REMARKS

This Amendment is a full and timely response to the Office Action dated March 3, 2004. A Petition to Extend the Time for this Response to Within the Third Extended Month accompanies this submission. Reexamination and reconsideration are respectfully requested.

AMENDMENTS TO THE DRAWINGS

Three (3) attached sheets of drawing include changes to Fig. 1, Fig. 2 and Fig. 10. The change to these Figures is as follows.

Fig.1*Fig. 1A*
(a)*Fig. 1B*
(b)

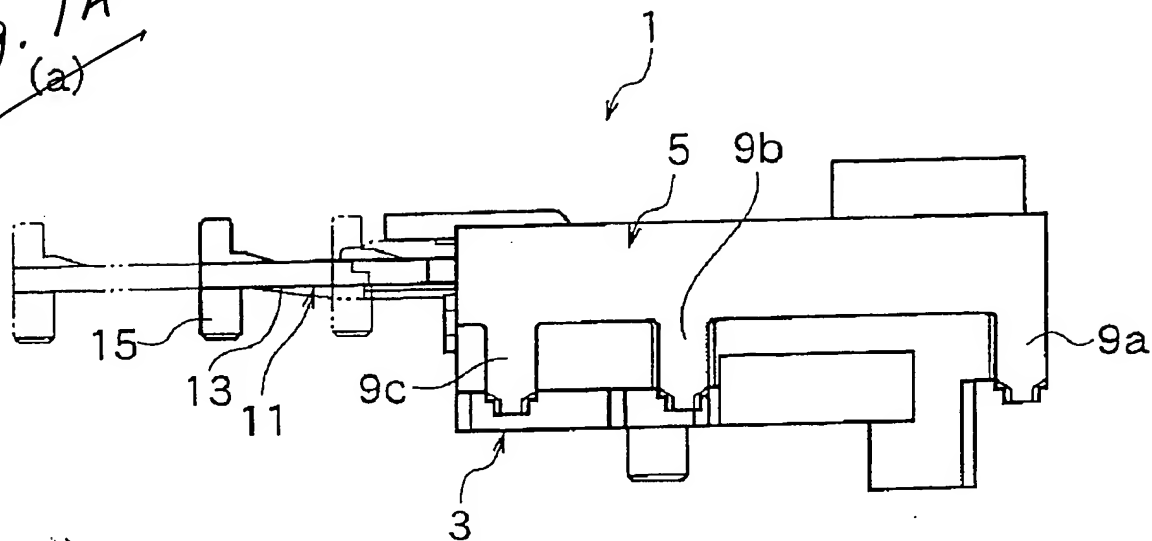
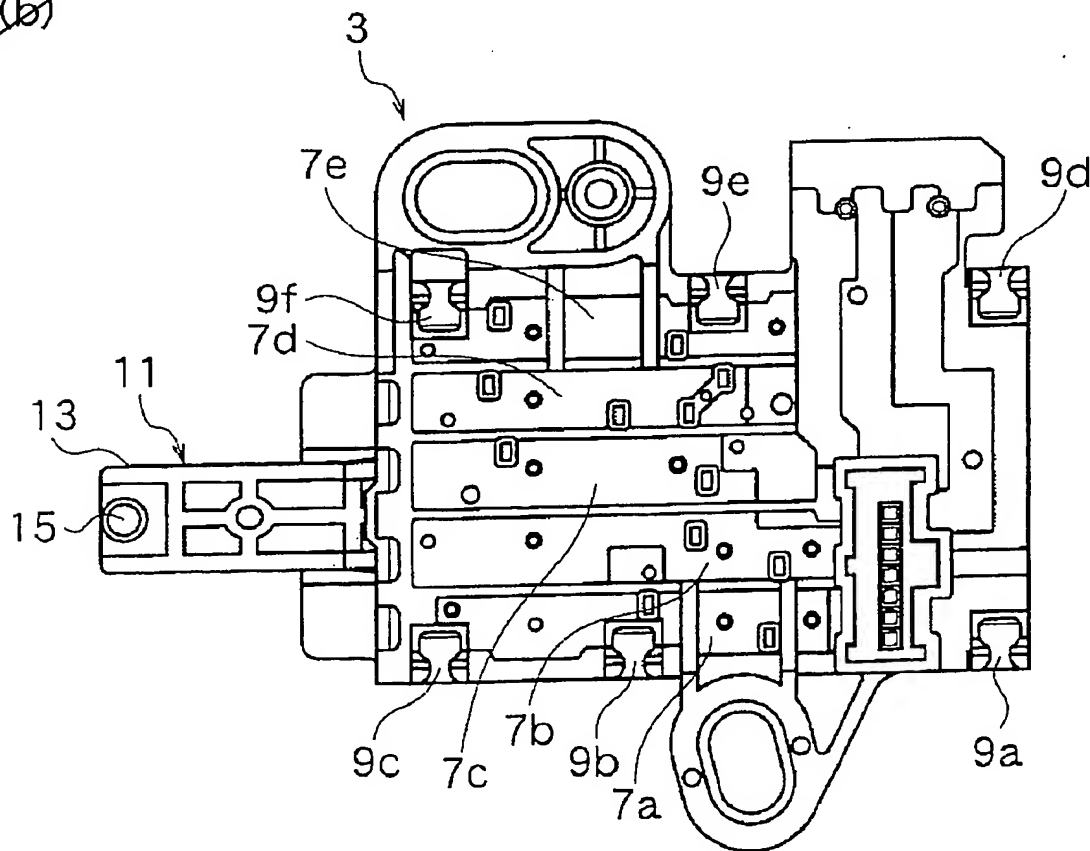
Changes are made to the drawings to conform with the specification. For example, Fig. 1(a) as shown in the drawings is referred to in the specification as Fig. 1A. Similar changes are made to Figs. 1A, 1B, 2A, 2B, 2C, 10A, 10B and 10C. No new matter is involved.

Sheet 1 includes Fig. 1 – Please amend the figure as follows – Fig. 1A and Fig. 1B.

Fig.2

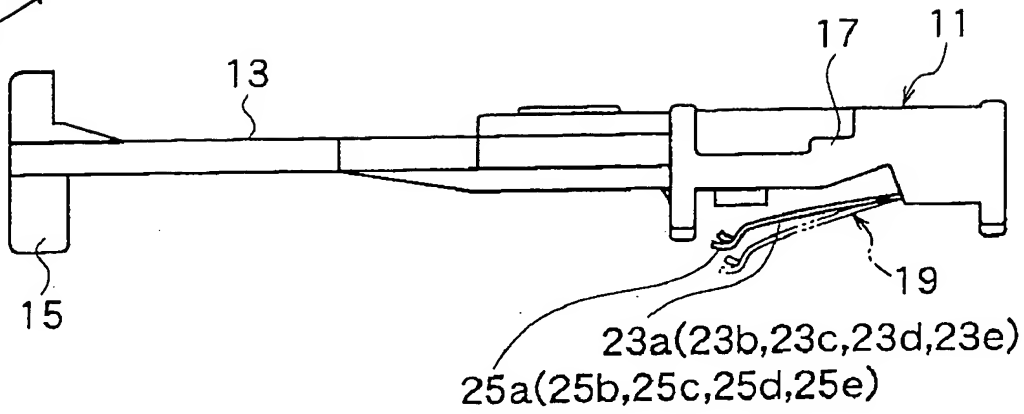
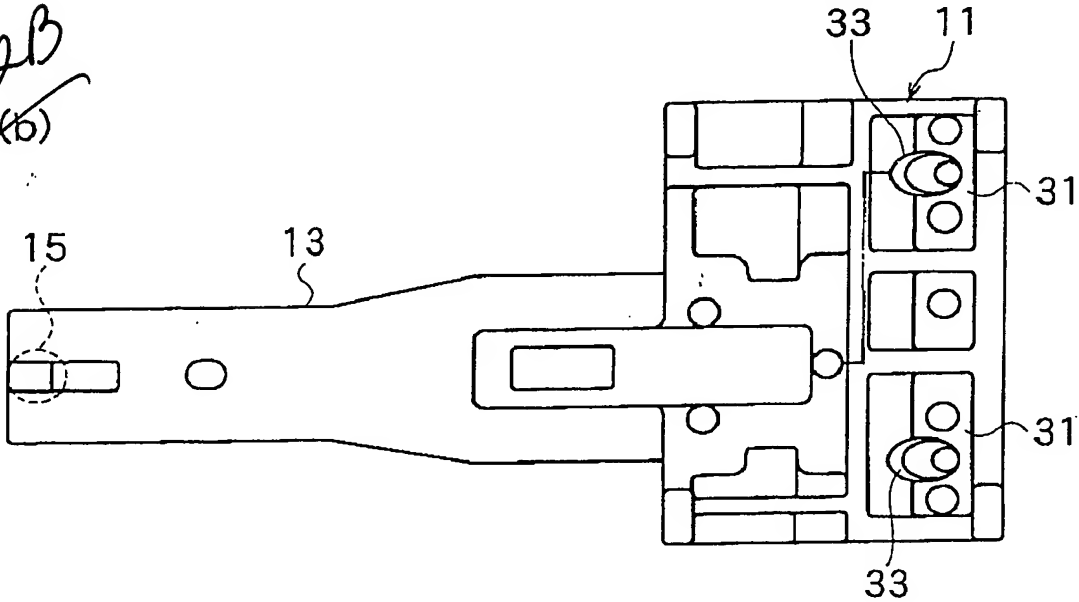
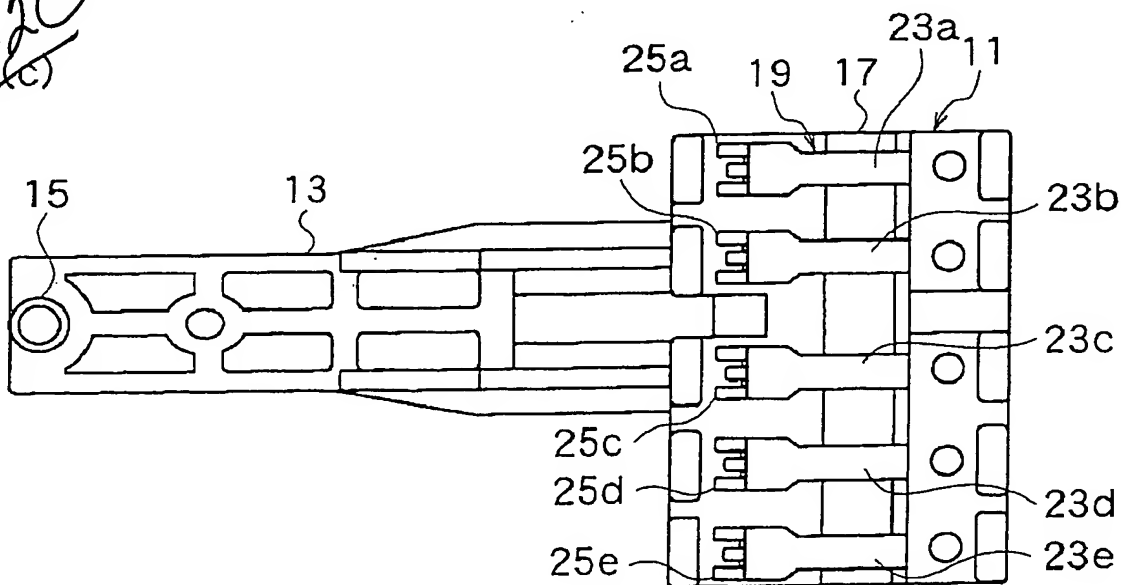
Sheet 2 includes Fig. 2 – Please amend the figure as follows – Fig. 2A, Fig. 2B, and Fig. 2C.

Fig.10

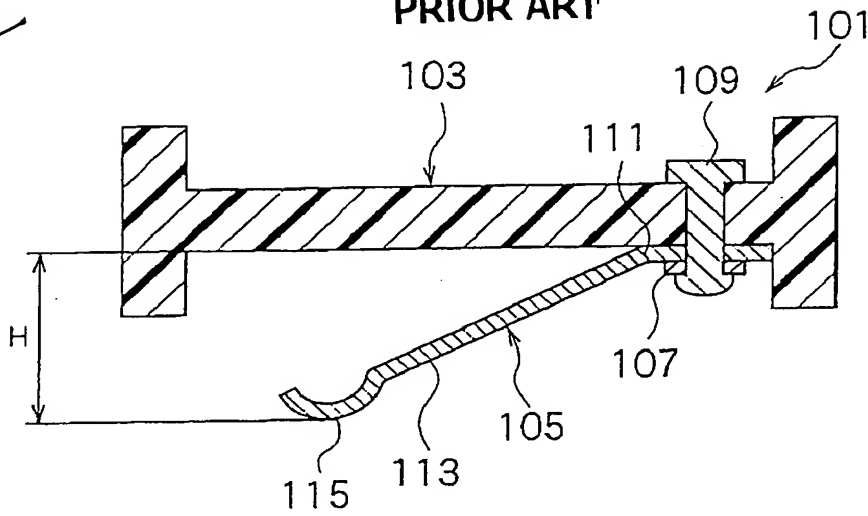
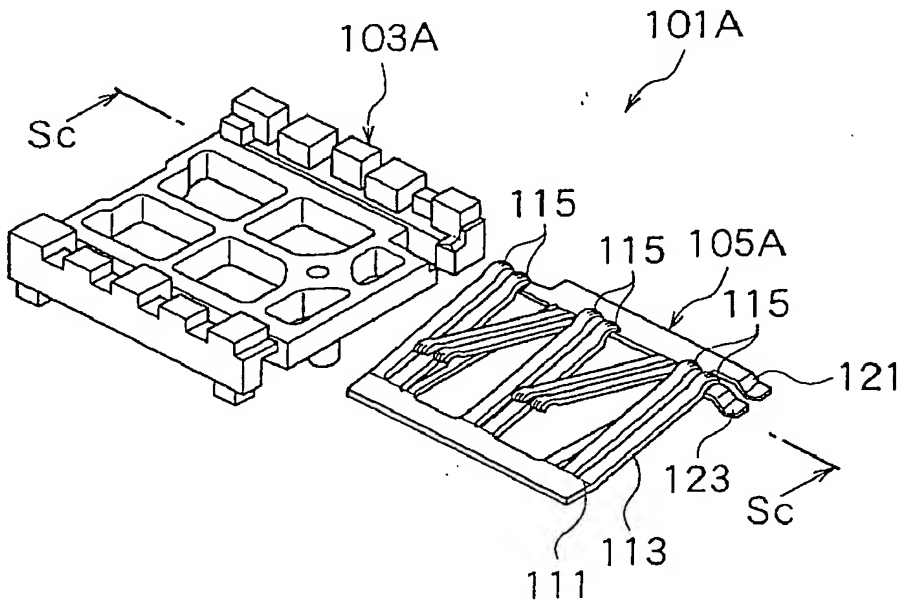
Sheet 3 includes Fig. 10 - Please amend the figure as follows – Fig. 10A, Fig. 10B, and Fig. 10C.
